CRANBROOK CRESCENT

SITE PLAN REVIEW

LOT NO 198 REGISTERED PLAN 6511-4500

SITE PLAN

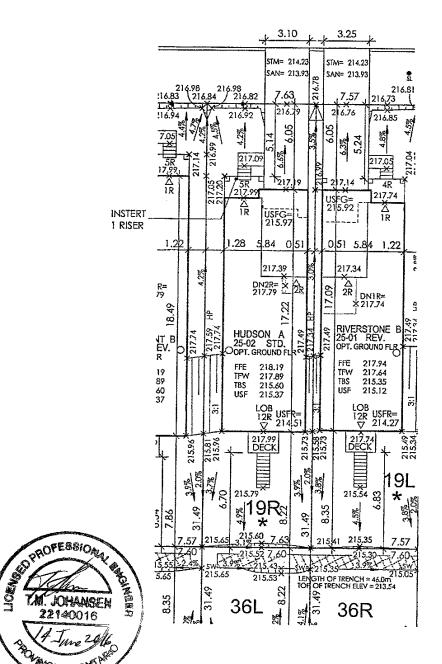
THE PROPOSED LOT GRADING AND DRAINAGE IS APPROVED AS BEING IN CONFORMITY WITH THE OVERALL APPROVED GRADING PLANS FOR THE SUBDIVISION.

NO COMMENT
